**De Zavala Elevated Storage Tank Project
Solicitation Number: CO-00409-FG
Job No.: 15-6001**

**ADDENDUM 2
August 18, 2021**

REF. NO. EST-06R Δ
 SHEET 18R OF 65

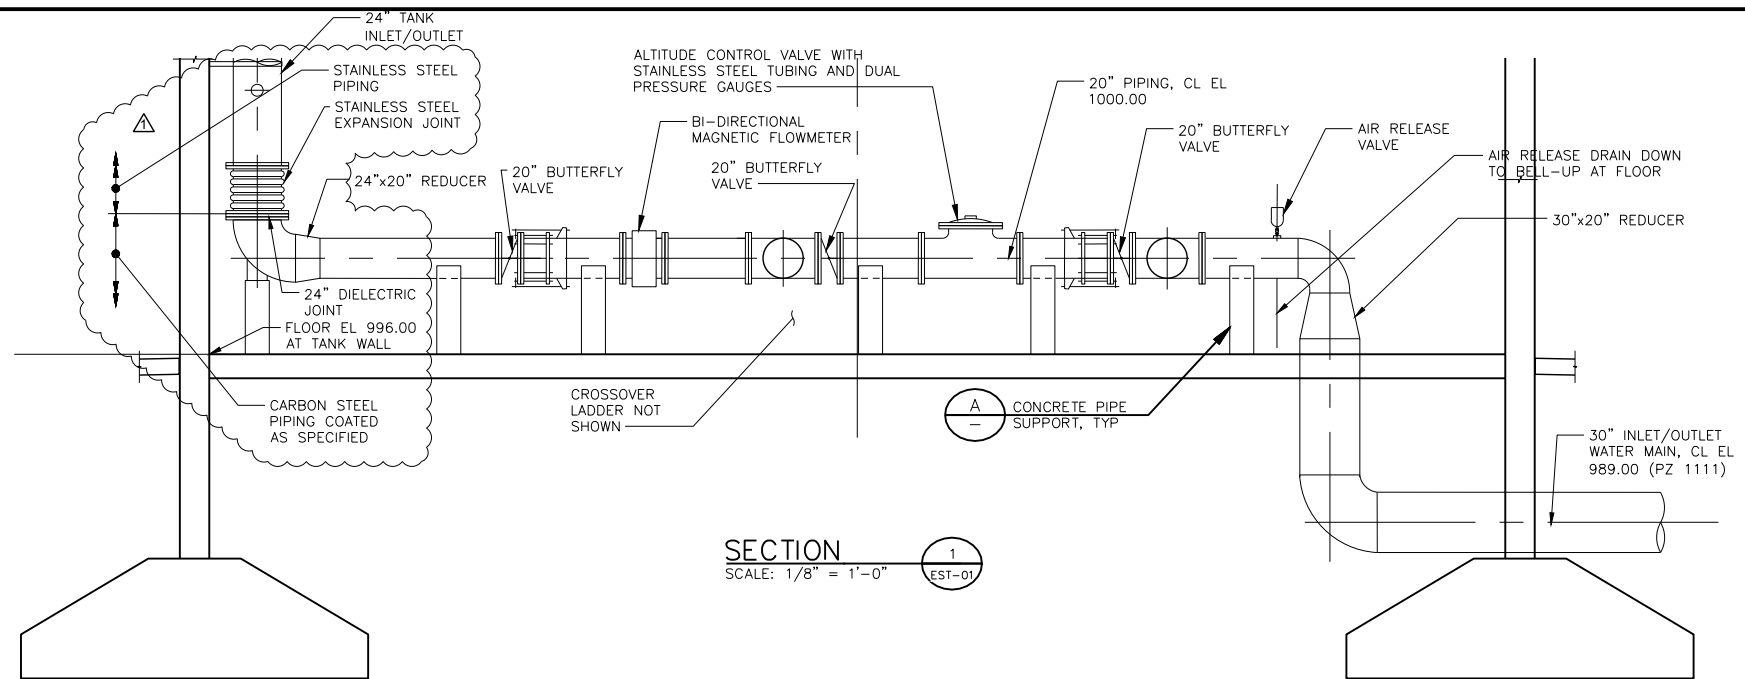
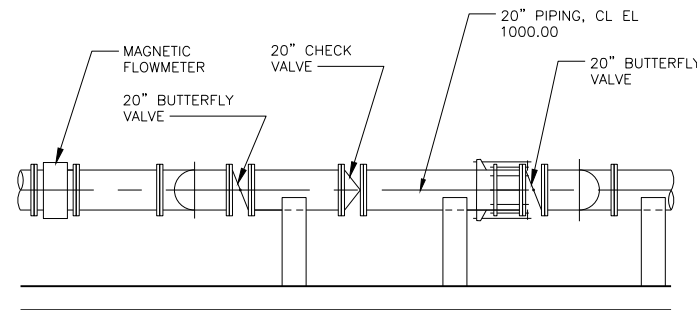
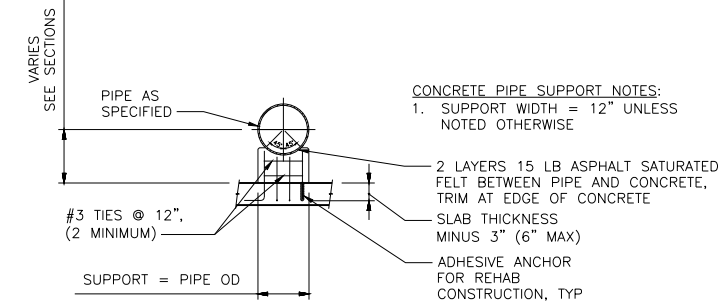
6. Question: DWG EST-06 Section 1 shows 30" tank inlet/outlet at the expansion joint. Other drawings and the tank spec require 24" for the inlet. Please clarify that this should be 24", and the base elbow is 24" diameter.

18. Question: There is a discrepancy in the number of vents at the top of the tower. The spec states a vent (I take this to mean 1). Dwg EST -05 states to provide 3 vents. Dwg EST-06 Misc Note 4 states A Removable Alum Louver. Please Clarify. 33 16 11 pg 10 par 2.06 J 1, dwgs EST-05, EST-06

Response: *Tank inlet/outlet and base elbow is 24" from expansion boot heading up into tank. Design Drawing EST-06, Sheet 18 of 65 has been modified as included with this addendum. Refer to "Changes to Plans" section as included herein/below.*

- Response: *See response to Question #11. Clarification: a 24" x 36" removable aluminum louver vent shall be provided. Bidder's shall further refer to Specification 33 16 11-12 for support structure ventilation code compliance.*

ROOF PLAN DETAIL
 NOT TO SCALE

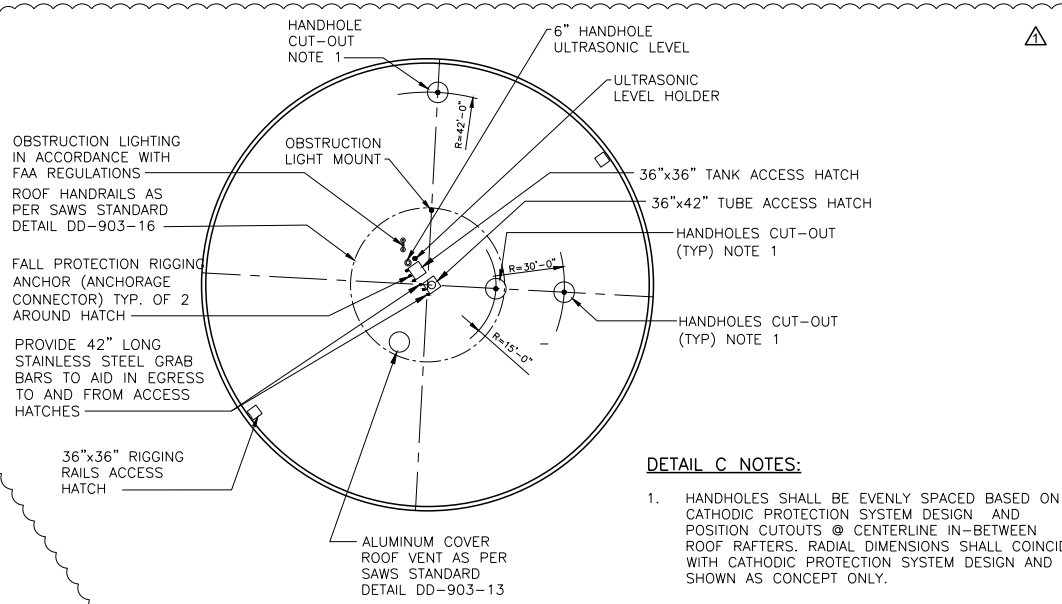
41. Question: Sheet 19 Roof Plan shows a 33 ft diameter roof handrail, Section 33 16 11 Item 2.06.I specifies an 18 ft diameter roof handrail. Please clarify.

- Response: *Bidders shall refer to SAWS Standard Detail DD903-05 and attention to revised Design Drawing EST-07R, Sheet 19R of 65. Refer to "Modification to Specifications" section 33 16 11-11 Item 2.06.I as included herein/below. Also refer to "Changes to Plans" (Design Drawing EST-07, Sheet 19 of 65) section as included with this addendum.*

6. Amend Technical Specification 33 16 11-11 Item 2.06.I; second sentence: REPLACE reference to “...minimum of 18 ft. in diameter ...” WITH “...minimum of 14 ft. in diameter...”

INTERIOR PLACARD
 SCALE 1/2"=1'-0"

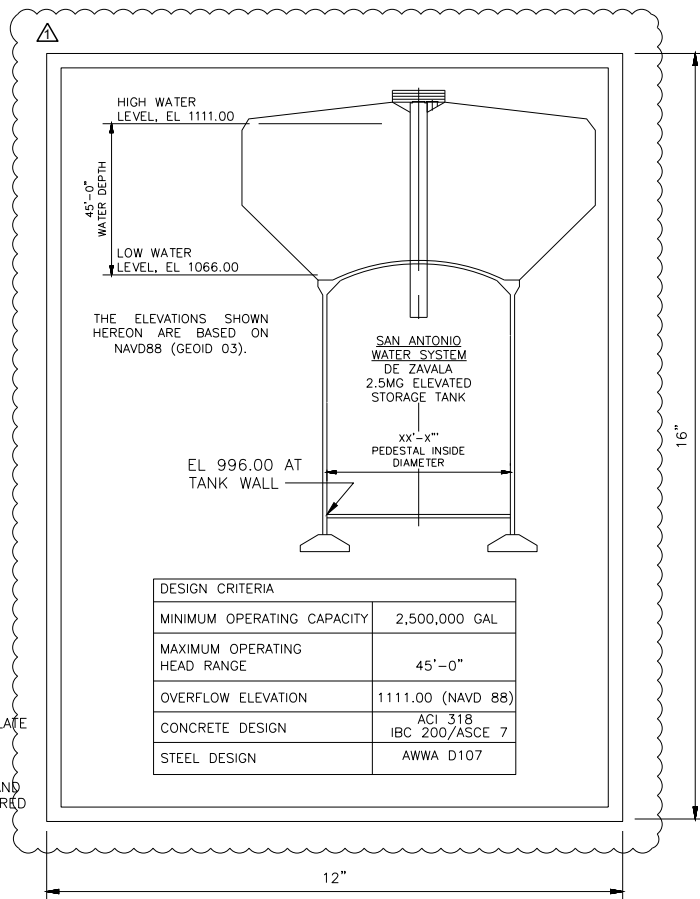
- Response: *Bid as currently specified. No change to Specification.*
40. Question: Please confirm we can ignore the 44'6" head range shown on the Interior Placard Detail on Sheet 19 as the drawings and specifications describe a 45 ft max operating range.

- Response: *Yes, 45' is the specified maximum operating range as detailed in Specification 33 16 11. Refer to "Changes to Plans" (Design Drawing EST-07, Sheet 19 of 65) section as included with this addendum.*
